UNITED STATES PATENT AND TRADEMARK OFFICE

APPLICATION NO.	FILING DATE	FIRST NAMED INVENTOR	ATTORNEY DOCKET NO.	CONFIRMATION NO.
10/766,041	01/29/2004	Mamoru Nakasuji	011470A	2576
38834	7590	04/05/2005	EXAMINER	
WESTERMAN, HATTORI, DANIELS & ADRIAN, LLP 1250 CONNECTICUT AVENUE, NW SUITE 700 WASHINGTON, DC 20036			JOHNSTON, PHILLIP A	
			ART UNIT	PAPER NUMBER
			2881

Office Action Summary

Detailed Action

FIG. 9

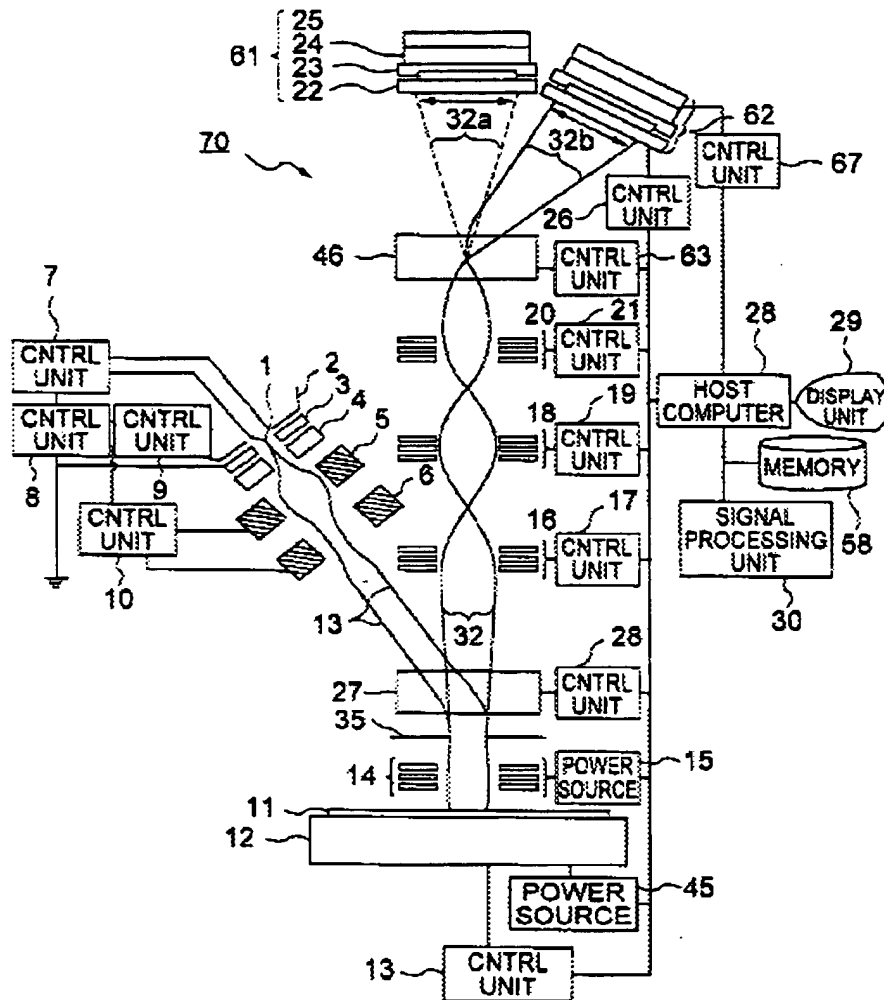
(a) An electron gun for emitting a plurality of electron beams, spaced apart at equal intervals to scan a semiconductor wafer, and a deflector 27 for deflecting secondary electrons toward the secondary optical system, that incorporates an E x B filter above the objective lens system 14, having coils 41a and 41b, equivalent in the shape of a toroid as recited in claims 58,59,61, and 63. See Column 10, line 42-55; and figure 9 below;

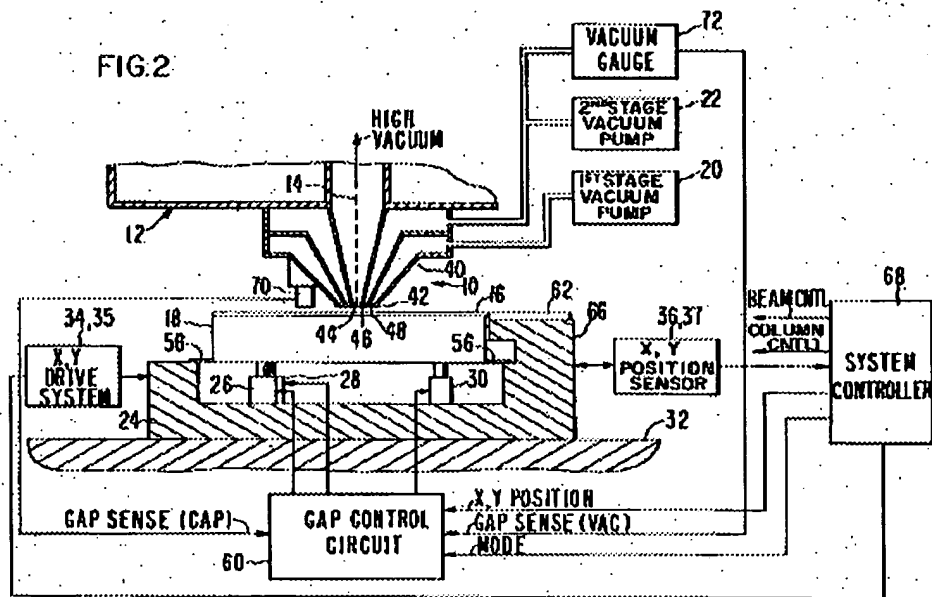
Yamazaki (018) fails to teach the use of a vacuum seal based on differential pumping, and a partition between the sample irradiation region and the working chamber to maintain a pressure difference between the sample irradiation region and the working chamber, as recited in claims 58, and 70-72. However, Petric (451) discloses an envelope apparatus 10 that provides a partition between vacuum zone 44 and the working chamber, where the envelope apparatus 10 includes annular aperture 48, which is coupled to the first stage vacuum pump 20 which reduces the pressure (differentially pumped) around the vacuum zone 44 to a low vacuum level. See Column 4, line 52-68; and Figure 2 below.
